UNITED STATES PATENT AND TRADEMARK OFFICE

APPLICATION NO.	FILING DATE	FIRST NAMED INVENTOR	ATTORNEY DOCKET NO.	CONFIRMATION NO.
10/575,860	01/25/2007	Kyu Young Kim	K-0800	6863
34610	7590	09/26/2007		
KED & ASSOCIATES, LLP P.O. Box 221200 Chantilly, VA 20153-1200			EXAMINER LEUNG, PHILIP H	
			ART UNIT 3742	PAPER NUMBER
			MAIL DATE 09/26/2007	DELIVERY MODE PAPER

Office Action Summary	Application No. 10/575,860	Applicant(s) KIM, KYU YOUNG	
	Examiner Philip H. Leung	Art Unit 3742

DETAILED ACTION

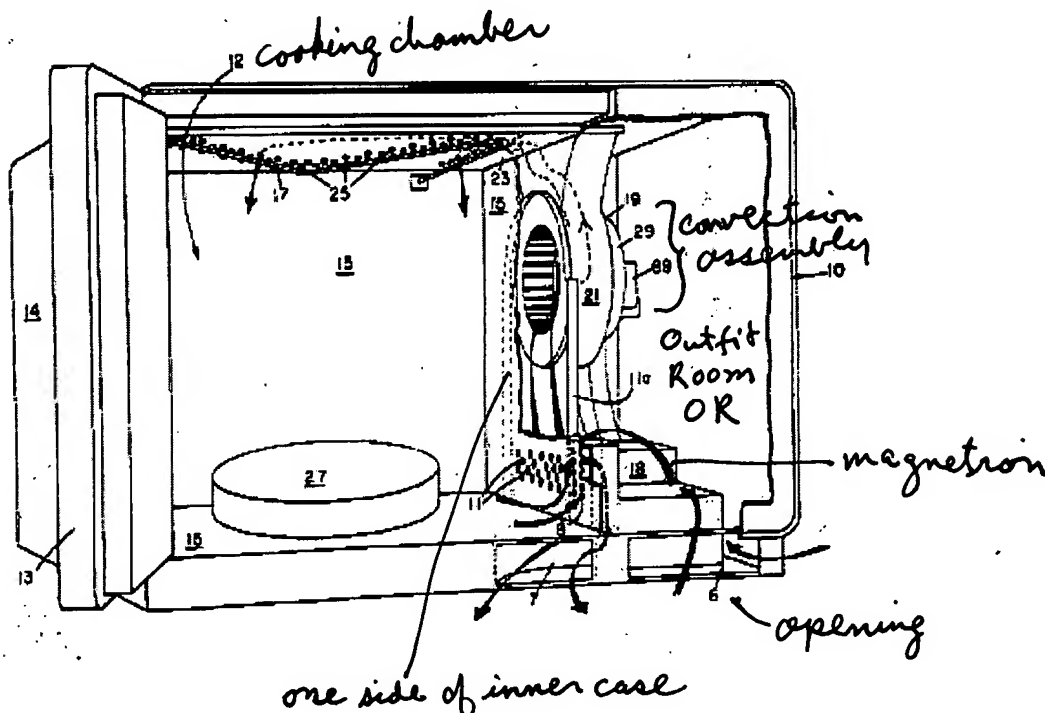
Larsen shows a microwave oven comprising: a body 10 forming an outer appearance; an inner case 15 in the body having a cooking chamber 12 formed therein; an outfit room (marked as OR) at one side of the inner case, having various electric parts, such as a magnetron 18, a high voltage transformer 92, mounted therein; and a convection assembly (19, 21, 29) mounted at a side of the inner case, for transmitting heat to the cooking chamber (see the marked-up copy of Figure 1 below).

In regard to claim 2, as shown in the drawing above, the convection assembly is in the outfit room (OR). In regard to claim 6, it also shows an opening 6 as claimed.
